SUNDRY NOTICES AND REPORTS ON WELLS (DO NOT USE THIS FORM FOR PROPOSALS TO DRILL OR TO DEEPEN OR PLUG BACK TO A DIFFERENT RESERVOIR. USE "APPLICATION FOR PERMIT" (FORM C-101) FOR SUCH PROPOSALS.)		WELL API NO. 30-025-30291
1. Type of Well: Oil Well ☐ Gas Well ☐ Other ☒ INJECTION		5. Indicate Type of Lease STATE ☐ FEE ☒
2. Name of Operator RAM ENERGY LLC		6. State Oil & Gas Lease No. 313857
3. Address of Operator 2100 S. UTICA AVE., SUITE 175, TULSA, OK 74114		7. Lease Name or Unit Agreement Name WEST DOLLARHIDE QUEEN SANDS UNIT
4. Well Location Unit Letter M : 1090 feet from the W line and 660 feet from the S line Section 19 Township 24S Range 38E NMPM County LEA		8. Well Number 129
11. Elevation (Show whether DR, RKB, RT, GR, etc.) 3136 KB		9. OGRID Number 309777
		10. Pool name or Wildcat 18810

**WELLBORE DIAGRAM
WEST DOLLARHIDE QUEEN SAND UNIT #129**

Operator: RAM ENERGY LLC 5100 East Skelly Drive Tulsa, OK 74135	OGRID: 309777
	Action Number: 28982
	Action Type: [C-103] NOI Plug & Abandon (C-103F)

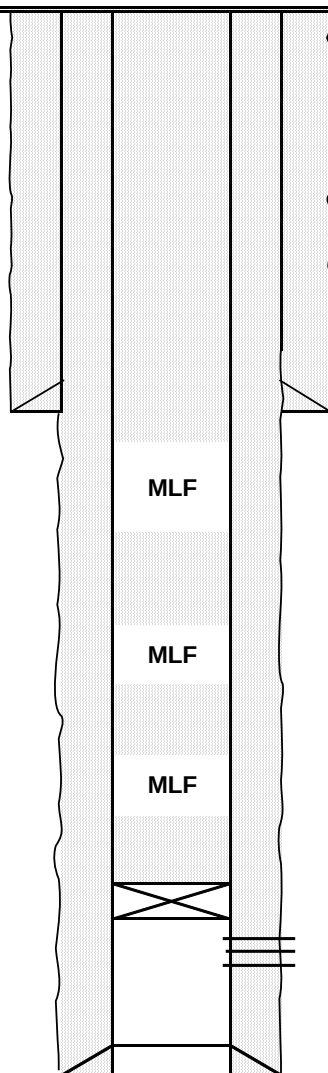
Attempt
to P&S
460

**Attempt
to P&S
460**
